# Grinnell®

Assignment 98-81                      Supplement to Submission

## Environmental Assessment

Please provide the following information to complete your amendment application for NR-776-D-101-E.

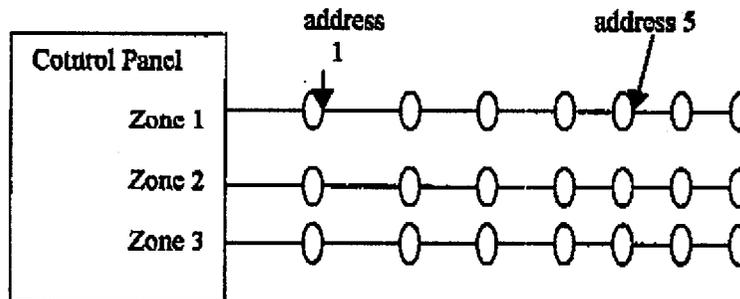
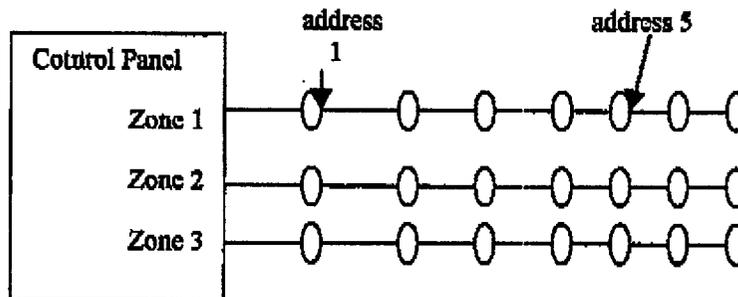
1. You stated in the application that the MF series and Nittan detectors are no longer manufactured and the personnel who filed the documents are no longer with the company. Therefore, I'll convert current NR-776-D-101-E into inactive status and issue new registration certificate for Lo-Pros series 612I and 912I detectors.
2. Please explain the terms for "addressable smoke detector" and "non-addressable smoke detector."
3. Please provide more detailed explanation for "... in plug in bases." What kind of plug is used? The drawing does not show the plug.

The non-addressable (612I) and the addressable (912I) detectors contain the same source element. The difference between the two detectors are in the electronic circuit board and the housings. The 912I has connectors imbedded in the plastic so that the "address" can be communicated to the control panel.

The non-addressable (612I) and the addressable (912I) detectors contain the same source element. The difference between the two detectors are in the electronic circuit board and the housings. The 912I has connectors imbedded in the plastic so that the "address" can be communicated to the control panel.
